Mitigation Project Name UT to Mill Swamp Restoration Project
 DMS ID 95019
 River Basin White Oak
 Cataloging Unit 03030001

Subject: Task 11: Response Letter to DMS review comments regarding the Draft Year 5 Monitoring Report for the UT to Mill Swamp Restoration Project (#95019)
White Oak River Basin – CU#03030001, Onslow County, North Carolina
DEQ Contract No. 003992, Baker No. 124578

UT to Mill Swamp Restoration Project Sixth Monitoring Measurement Fifth Year of Credit Release - FINAL

Figure 3. Cross-sections with Annual Overlays.

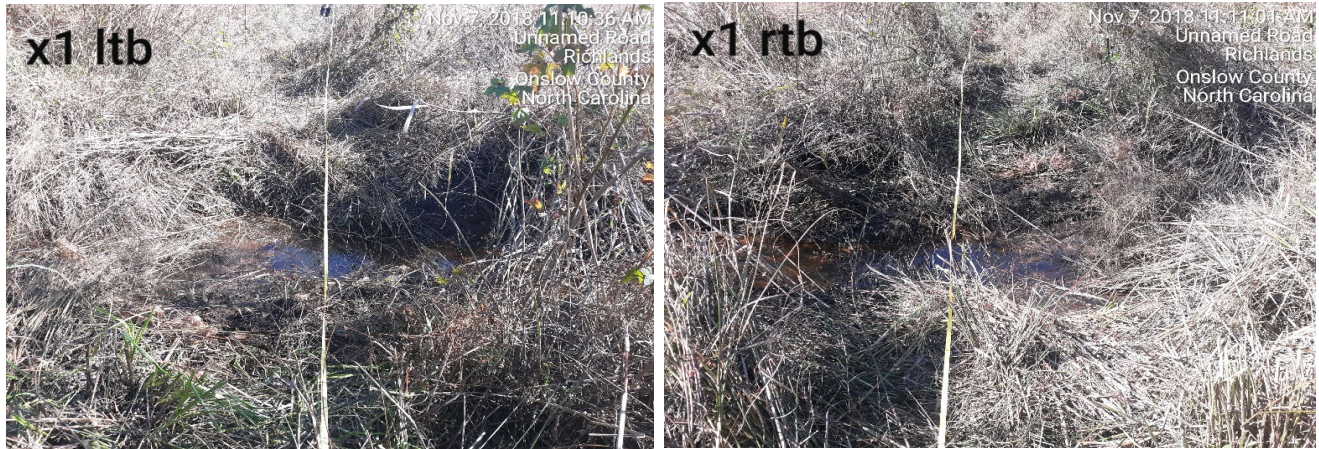
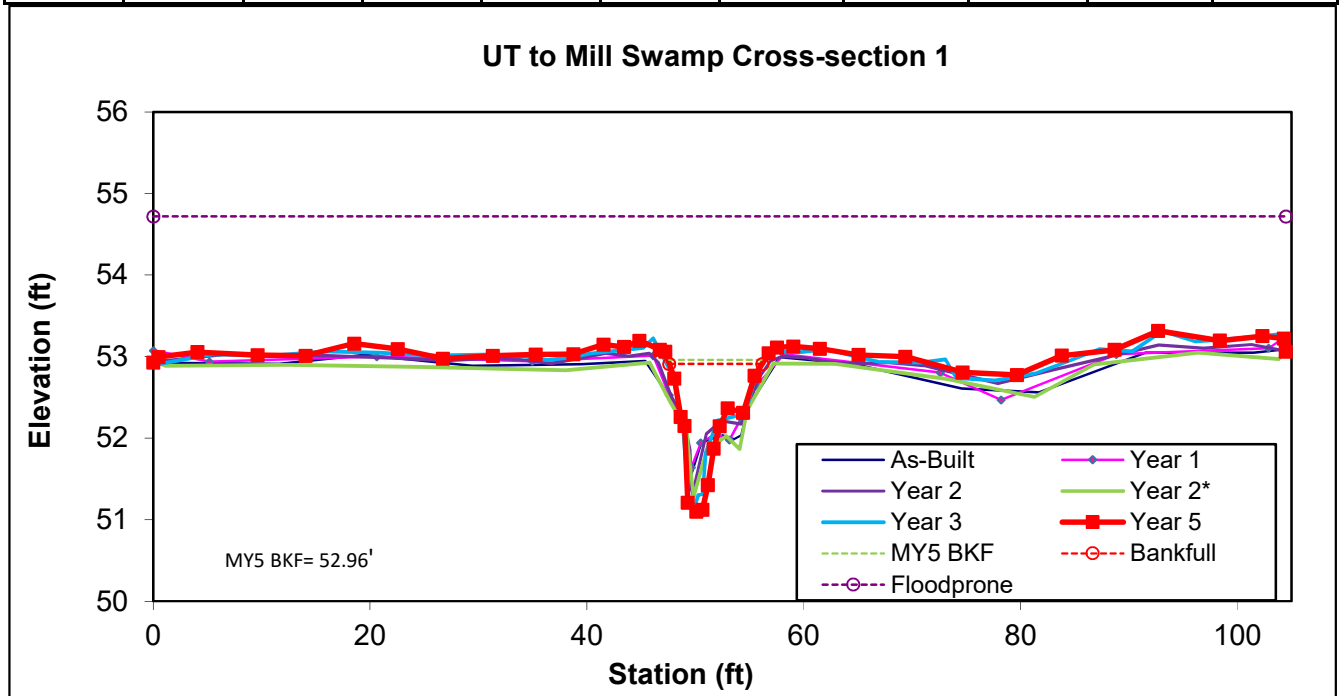
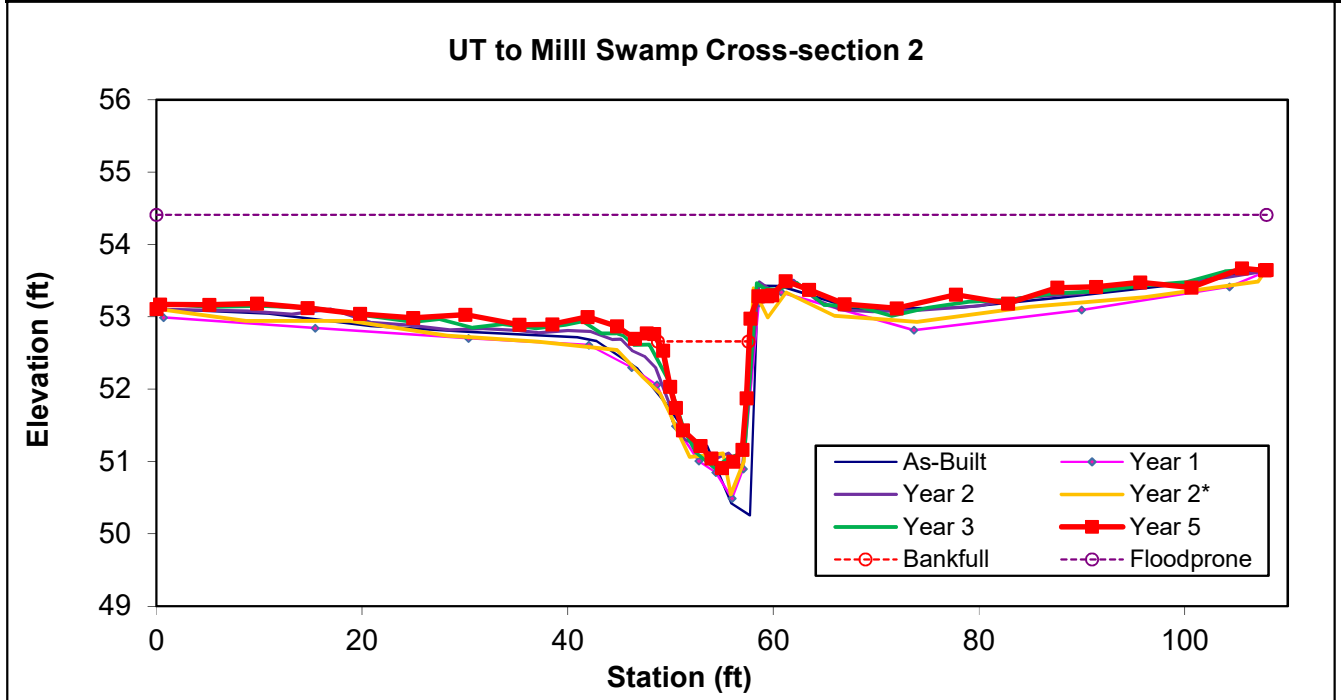
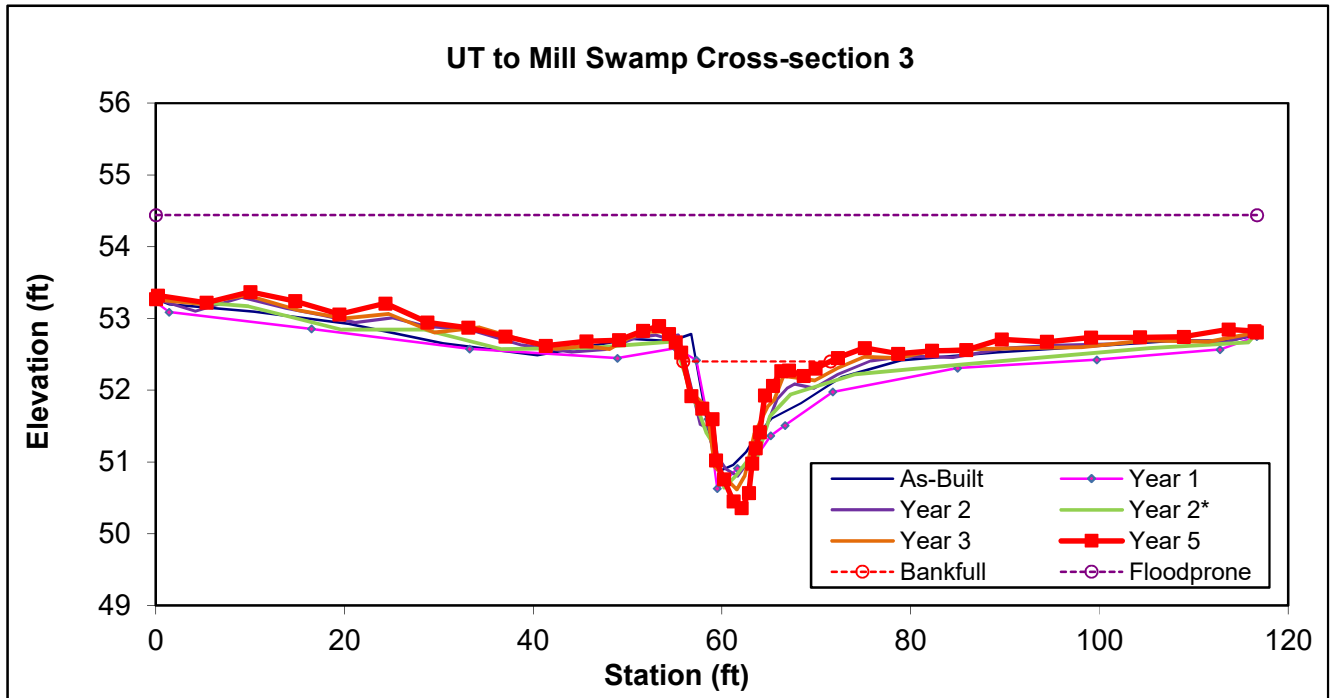
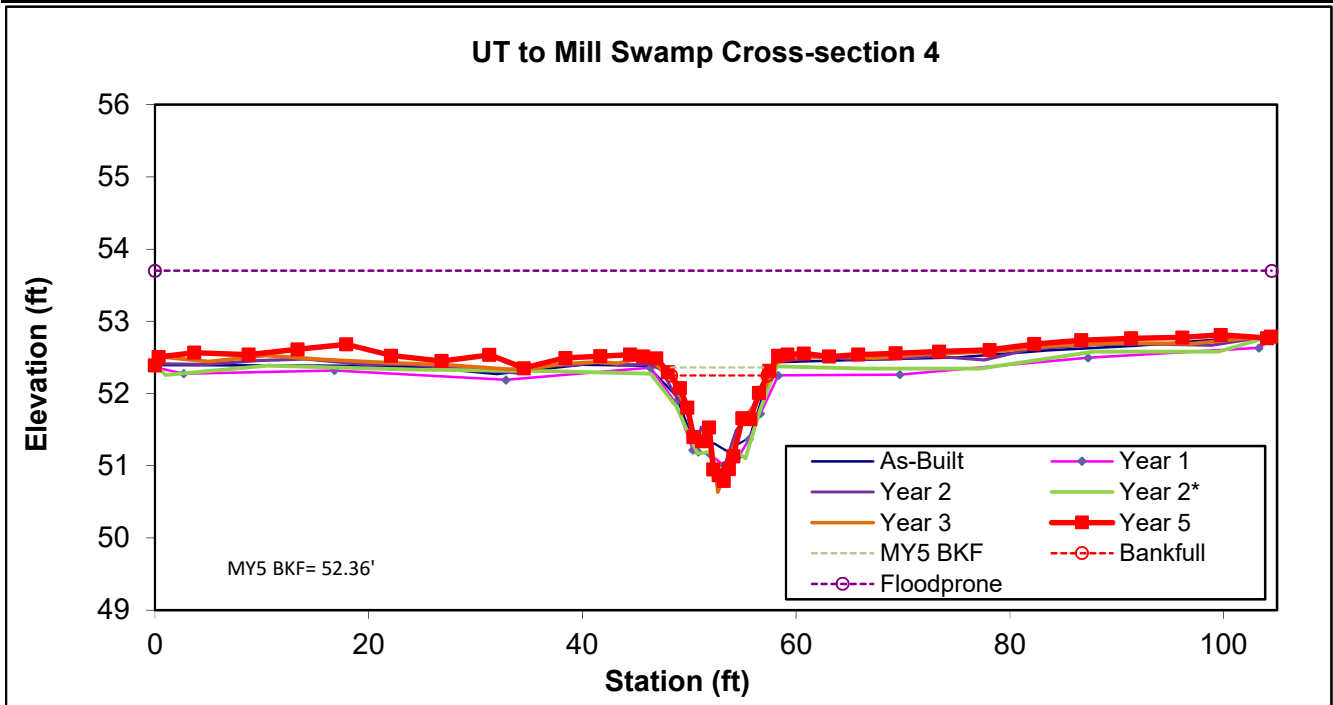
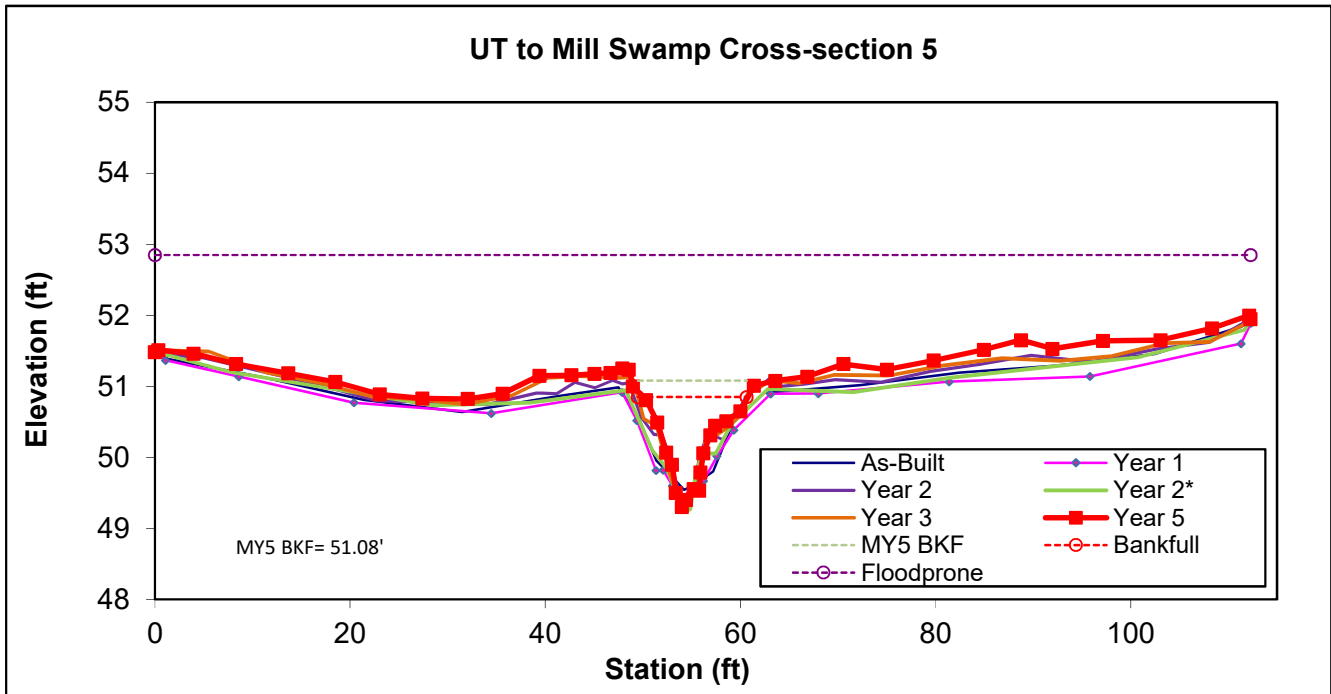
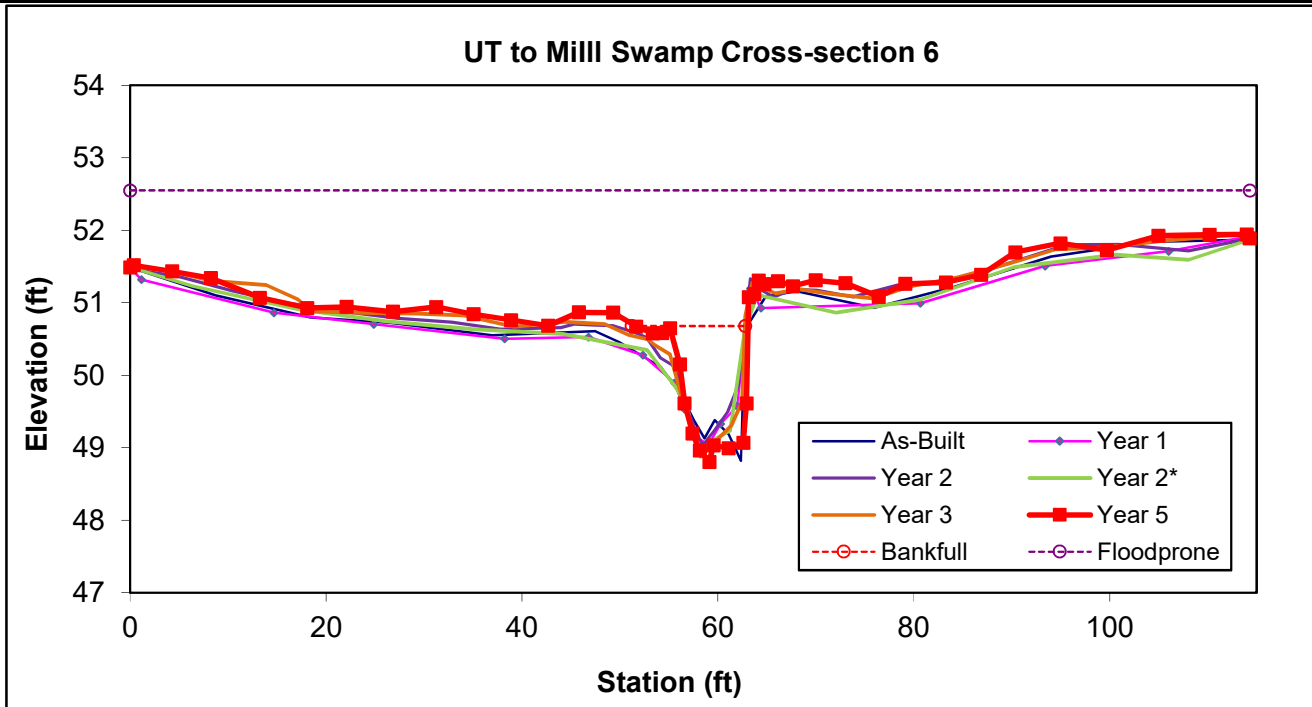
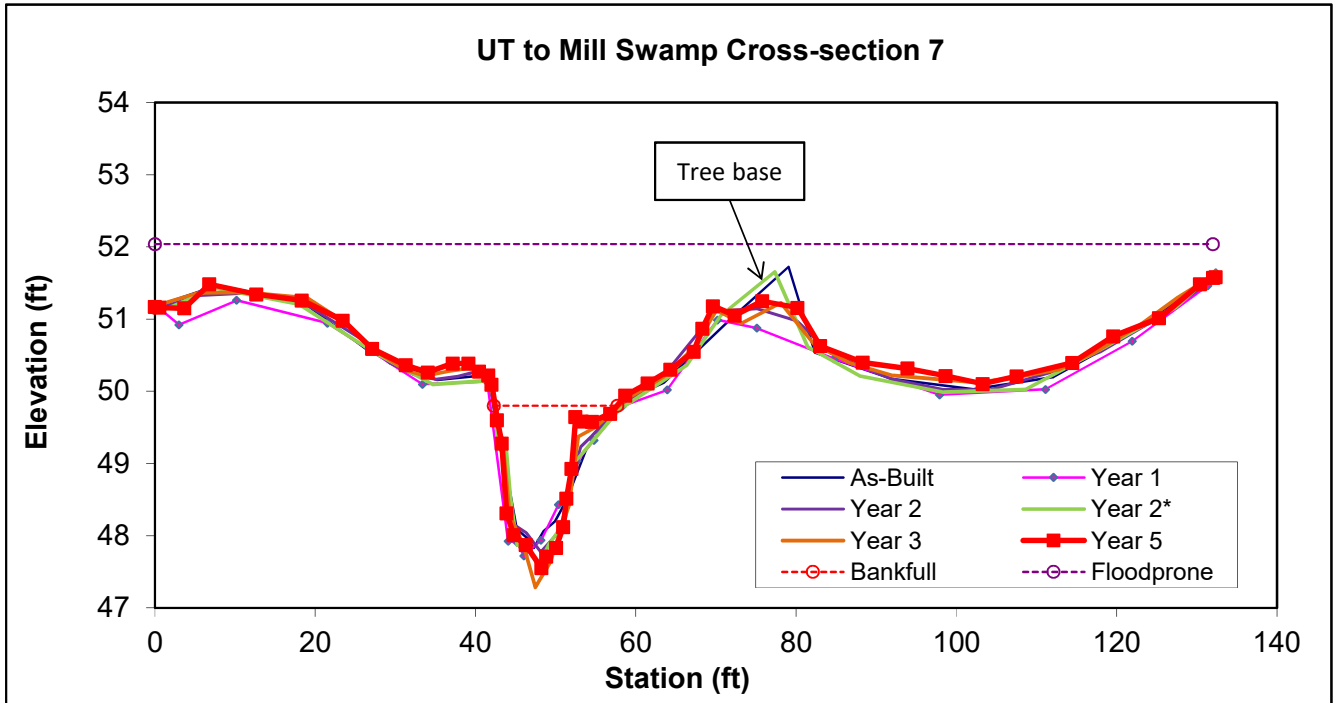
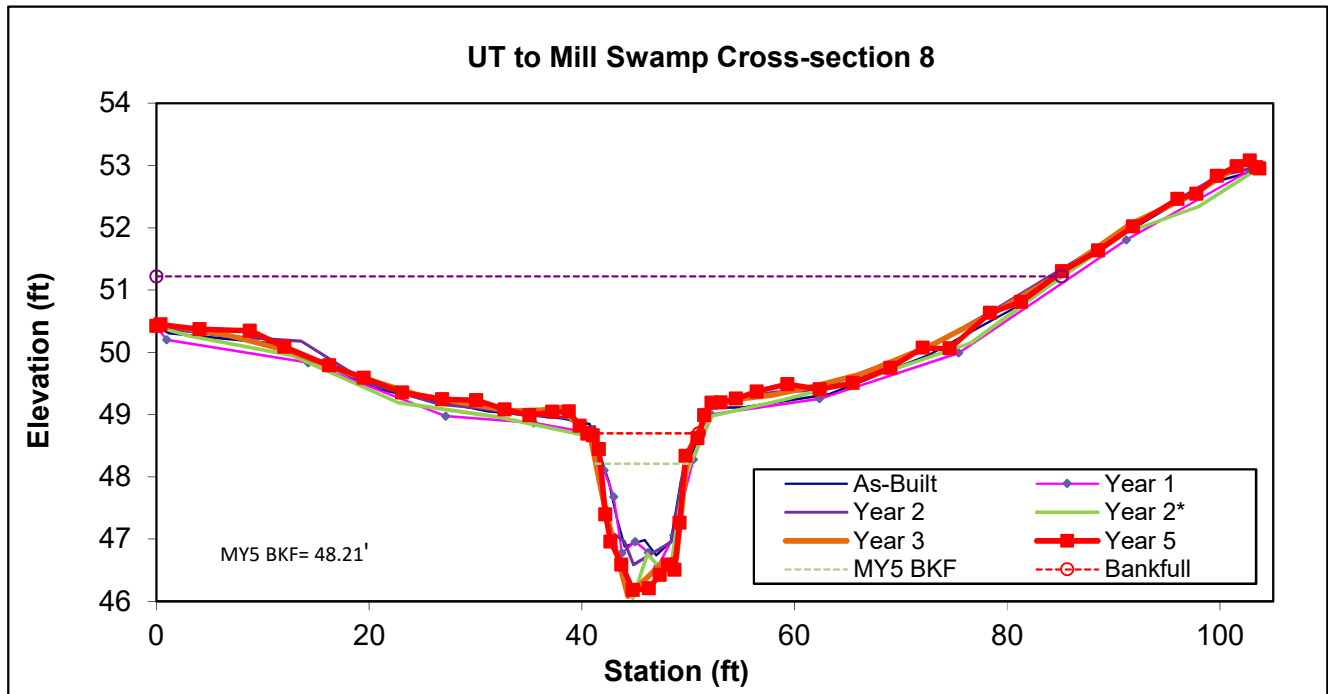
5. Appendix D, Table 11: During our review of the Bank Height Ratios (BHR) in Table 11, DMS staff performs a visual comparison of the MY5 data to As-Built/Baseline cross-sections. DMS noted/realized that by displaying the As-built Bankfull Cross-Sectional Area alone, the calculation for the BHR can be difficult to reconcile. We noted possible discrepancies in the BHR calculations for cross-sections 1 and 5 given this disconnect. Using the new BHR calculation methodology where the As-Built Bankfull Area is held constant, please display the Year 5 bankfull elevation as another data series just for the sake of clarity between the BHR calculation and the overlay. It appears that the BHR calculations were done correctly, but just please add the MY5 bankfull data series with its elevation for the sake of clarity to the reader.

Response: An additional data series was added to each cross-section figure showing the MY5 bankfull line (generated using the as-built bankfull area as per the recent DMS memo) as requested. The BHR calculations for the listed cross-sections were re-checked again and were all confirmed as correct. With the new bankfull line shown, a visual comparison between it and the MY5 cross-section data certainly makes the BHR value appear to make intuitive sense.
